## Planning Committee – Hybrid Meeting

**Subject** **Planning Application Schedule**

**Proposal:** **DEMOLITION OF EXISTING BUILDINGS AND THE CONSTRUCTION OF 30NO. APARTMENTS ALONG WITH ASSOCIATED PARKING AND EXTERNAL AREAS (AMENDED PLANS RECEIVED)**

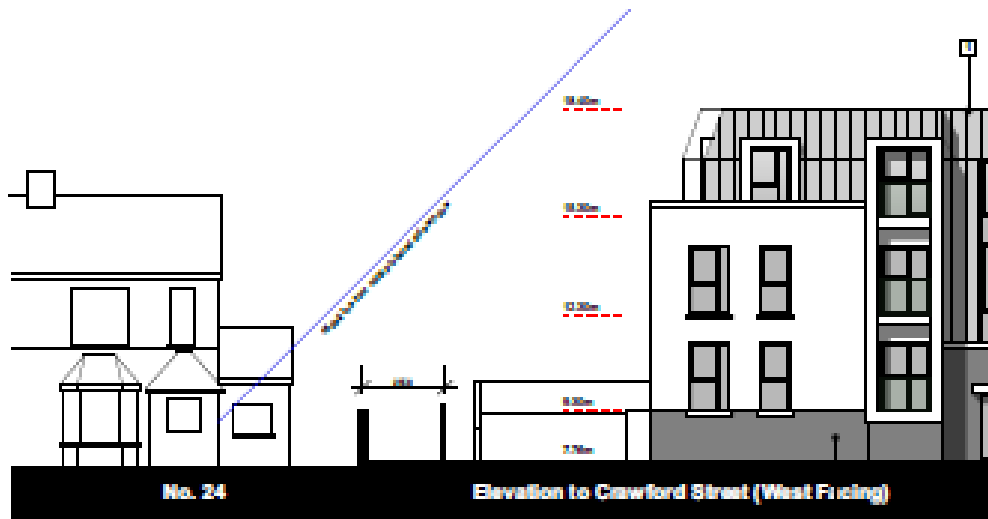
- 7.12 Due to the requirement to raise the site levels in the interest of flood risk retaining walls are required to the north, east (rear) and south of the site. No retaining walls are required to the front of the site along Crawford Street which is instead treated with a landscaped frontage and railings to ensure visual softening and defensible space. The retaining walls would have a maximum height of 2.6m and are shown to be smooth finished concrete. The retaining walls either end of the development would reduce in height where they meet Crawford Street and it is not considered that the retaining structures would result in an adverse visual impact to the street scene or character of the area. The most prominent retaining wall will be at the rear of the site along Herbert Road. Herbert Road is not fronted by dwellings and is a low trafficked road, as such the retaining wall would not result in an adverse impact to a prominent

street scene. However, the wall will require railings or similar above in the interests of safety of the users of the site to prevent them falling. These walls will also need to be finished in robust and visually acceptable materials and colours that will age well. It is considered that a condition requiring full details of such treatment to be submitted for approval is warranted.

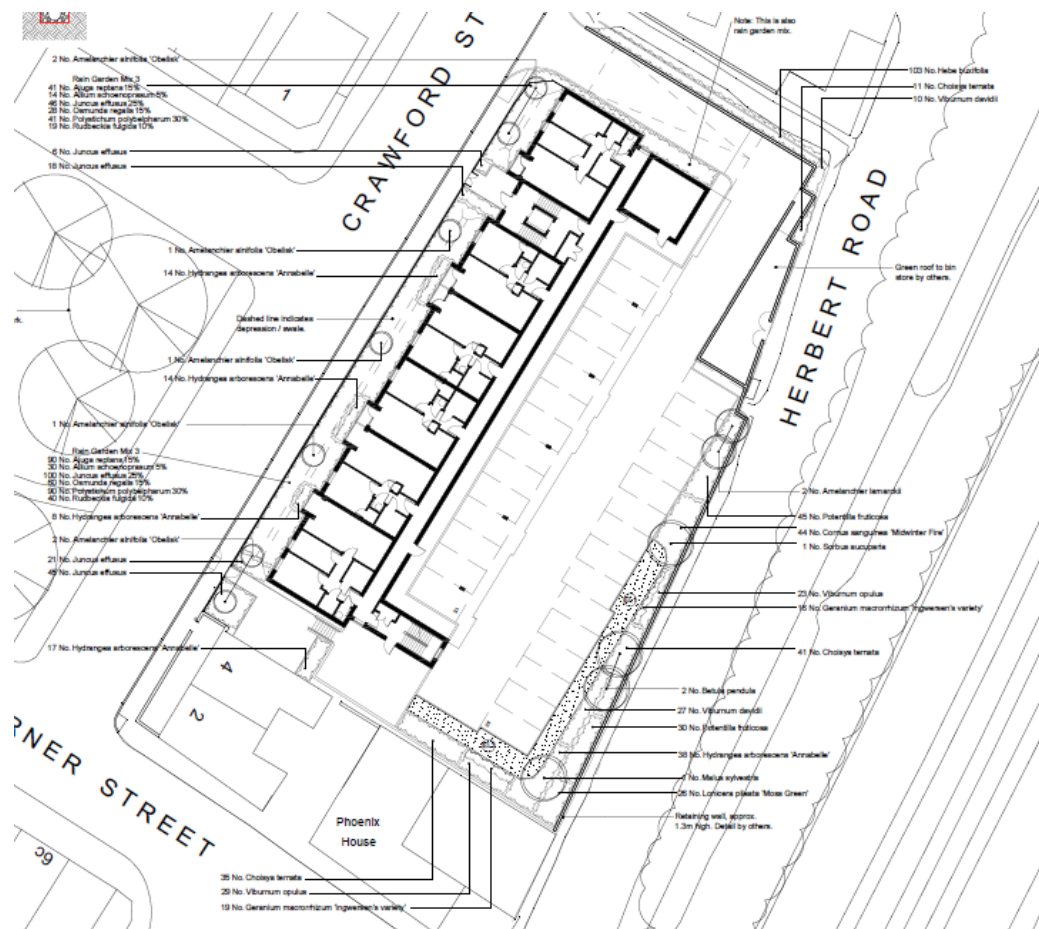
The properties will be flood free in all events, the access road will not be flood free in the extreme event and will flood in excess of 1m. However, velocities are expected to be within the tolerable limits. This test is not met by reason of the excess water on access roads in the extreme event.

- 7.40 In summary, the FCA has demonstrated that based on the proposed finished ground levels, the residential element and the car parking element of the proposal are predicted to be flood free and it includes an assessment of the 0.1% (1 in 1000 year) event including climate change allowance (CCA) over the life time of development. The site access in the vicinity of the highway and connection and the proposed bin store are predicted to flood and are therefore not compliant with TAN15. However, this is necessary to make the connection to the highway and to provide level access to the highway for waste collection.
